**TOWN OF JUNO BEACH**  
**November 13, 2020, 3:00pm**

**REQUEST FOR PROPOSAL - Renovate Two Dune Walkovers located at 530 & 800  
Ocean Drive**

**SUBJECT: Question and Answers Report**

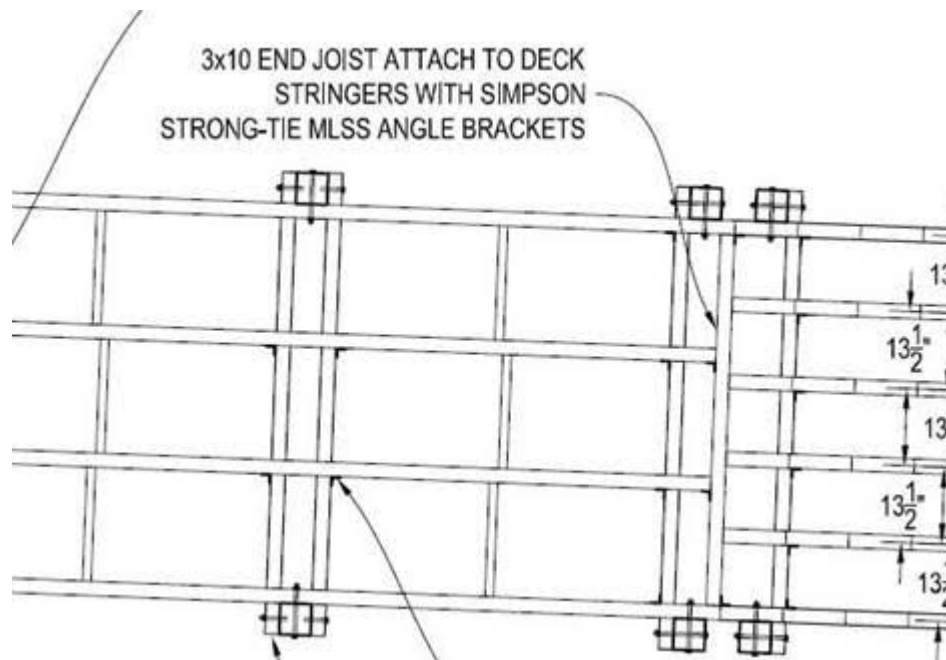
Please clarify the size and quantity of the Simpson MLSS Angle Brackets shown here:

**2: ANSWER:**

Four (4) total ML26 SS angle brackets connecting the end joist to the four (4) stringers of the flat access deck.
